City of Toronto – Parks, Forestry & Recreation

New Park at 134 Portland Street

Phase 1: Proposed Design

Survey Summary Report

New Park at 134 Portland Street Concept Design

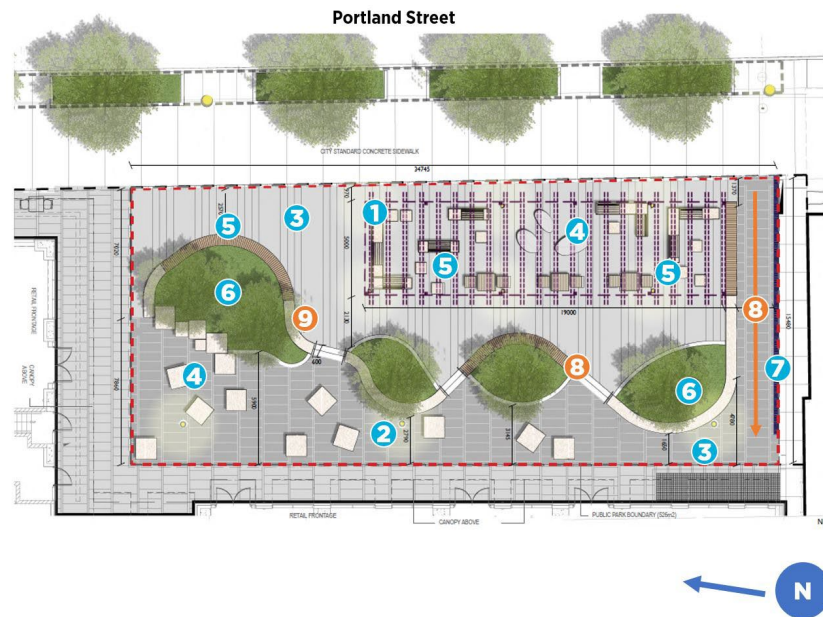
- My concern is for the park not to become a place where people drink alcohol, smoke weed and/or sleep as they already do on Portland Street. Seeing the result of Loblaws selling alcohol and inhaling weed smoke as I walk in this area does not make me feel safe, or in any way comfortable; rather, it just saddens and depresses me. This may become another place for these issues to flourish.

- This is truly awful. Trying to do too many things in this tiny park space. Pick one of two. Everyone needs more foliage and planting, perhaps some fenced beds in a unique shape with tree and native wildflowers in them. Due to the number of food offerings in the area place some formal seating the like tables and chairs and a shade canopy and be done with it. The park is tiny, fix your issues with parkland in the area before you ruin another minuscule space and produce less useful parkland for the city

- The benches should have back support. The shade structure could be supplemented by shade from trees
- The first priority of any park design, especially one on corner like this, is to streamline pedestrian flow. Note where the desire path will be, then design the park around that. This park design doesn't do that. It places the planting beds directly in the diagonal path that pedestrians would like to take across the park. The diagonal doesn't have to be a direct straight line, it could curve a bit, but it should be a direct line across the park without pedestrians feeling like obstacles are in their desired path. Seating in most recent City park like in Grange Park is awful. The flat seat and back is uncomfortable. The seat and back should be curved to fit people better. Lighting should be indirect, not harsh from bare bulbs. Again, look to Grange Park to see what not to do. There, the bulbs are bright and bare - lots of light, but it's counterproductive. Make the gardens beautiful, like at the Music Garden by the waterfront. Use trees for shade, rather than the canopy.

- I'm sure it's there, but what about garbage receptacles? How about a place to charge your phone or computer?
- Lose the shade structure all together. With the adjacent buildings, strategically placed trees in good growing conditions are sufficient (actually better). The suggested light fixtures read as sterile and cold, they have no flavour, they would be suitable to a prison yard. The LED (under seating) lighting just reads as light pollution. Rethink everything. Start over.

- Please look at every small parkette in NYC to see what green space with chain link fence and park benches look like. Simple concept that is easy to maintain. Your design is too concrete forward and tables will not get used for most of the year. Shame.

- Keep it simple and high quality - there is too much happening for such a small space. This should be a quiet, meditative garden-like space. It is over-programmed. Less paving, more gardens.

- More greenery/green space
- There should be more green space. The city is a concrete jungle, we need more grass rather than pavers.
- Neither shade design looks like it will actually provide shade. Needs to be something a bit more substantial

- The use of paving (textured or otherwise) feels unimaginative in an area of the city that is dominated by concrete. It will undoubtedly make for a very hot park in summer, even with shading.

- Include options like high line in nyc Add more greenery grasses .. lounge chairs ..
- Play structure is missing
- More grass
- Dog park and playground
- The cubes aren't welcoming at all or look like seating. Needs at least double the trees. This looks like an odd entrance plaza and not a public park.

- More plants and grassy area
- Partial natural play pieces for kids that could be used for sitting or multipurpose use for all.
- I like the layout and amount of seating, but I don't like the paving. There is already a really similar park behind 525 Adelaide St W with exactly the same mixture of seating/trees/paved ground which suits my needs for that. I would prefer a park with more grass so I could sit with friends to have a picnic, or play with my kid.

- We need MORE green space and less pavement. Pavement + seating doesn't equal a park. Give us reprieve from a concrete jungle.
- More soft cover. No grass to sit on in the summer. All that pavement will be so hot on those 25+ degree days.

- The shade structure seems oxymoronic: its supposed to provide shade but in each concept there are holes or slat openings, so then there would be sun and rain coming through it. Generally, its a really confusing space, by just looking at it, the point it seems to serve is for people to have a place to eat outside, and that is it. This doesn't seem like an efficient use of space. There is way too much concrete, and not enough greenery and the two types of trees that will be there isn't enough. Its not a beautiful space either. It would

- It would be better to switch the placement of the informal seating and the covered seating so that the covered seating sits closer to the building and the pebble seating is closer to the sidewalk and more welcoming and accessible. However, this isn't critical. The two designs presented may require change. They are both not pleasing aesthetically. The first design is a bit better than the second but the designers could come up with a better design and colour scheme. The red or hot pink is not a good look nor are the random cut-outs. There is very little grass and trees to call this small space a park. I would suggest much less concrete, much more grass and trees.
